Item Name: Crosstube Turning Detail

DART AEROSPACE LTD		Work Order: 83096
Description: Crosstube Assembly (205/212 High Aft)		Part Number: D212-664-241
Inspection Dwg: D212-664-241 Rev: D		Page 1 of 1

DRAWING NO. D212-664-241	TITLE CROSSTUBE ASSY (205/212 HI AFT)	REV. D	DART AEROSPACE LTD ENGINEERING ORDER		D.E.O. NO. D212-664-241-D-1	SHEET NO. SHEET 1 OF 2	SCALE NTS
DRAWN	CHECKED	MFG. APPR.	APPROVED	DE APPR.			
DATE 11.04.07	DATE 11.04.11	DATE 11.04.12	DATE 11/04/12	DATE 11.04.12

DRAWING NO. D212-664-241	TITLE CROSSTUBE ASS'Y (205/212 HI AFT)	REV. D	DART AEROSPACE LTD ENGINEERING ORDER	D.E.O. NO. D212-664-241-D-2	SHEET NO. SHEET 1 OF 1	SCALE NTS
DRAWN <i>90</i>	CHECKED <i>ASS</i>	MFG. APPR. <i>8</i>	APPROVED <i>MP</i>	DE APPR. <i>#4</i>		
DATE 11.07.15	DATE 11.07.20	DATE 11.07.21	DATE 11/07/21	DATE 11-07-21

D212-664-241/-241B
ASSEMBLY DETAIL

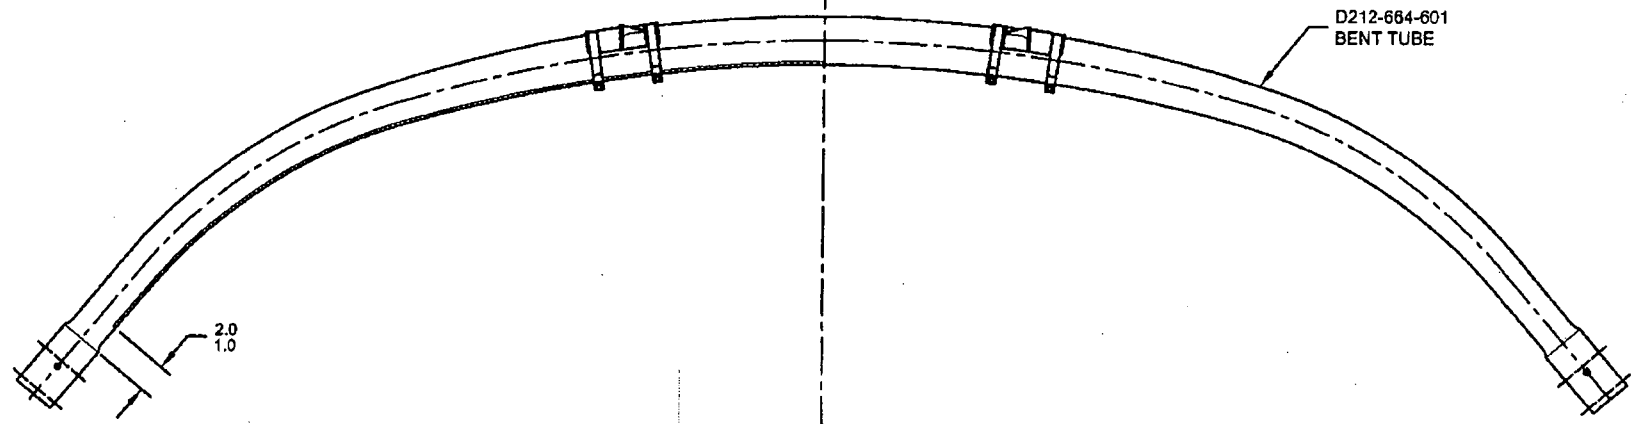
ADD AN INSPECTION WINDOW TO UNDERSIDE OF CROSSTUBE.

MASK AREA PRIOR TO PAINTING,
REMOVE MASKING AFTER PAINT
AND APPLY CLEAR COAT

- 2) FINISH: CHEMICAL CONVERSION COAT PER DART QSI 005 4.1
PRIME INSIDE AND OUTSIDE PER DART QSI 005 4.2
MASK UNDERSIDE OF CROSSTUBE AS SHOWN (HATCHED AREA) AND
PAINT OUTSIDE PER DART QSI 005 4.2
REMOVE MASKING AND APPLY CLEAR COAT
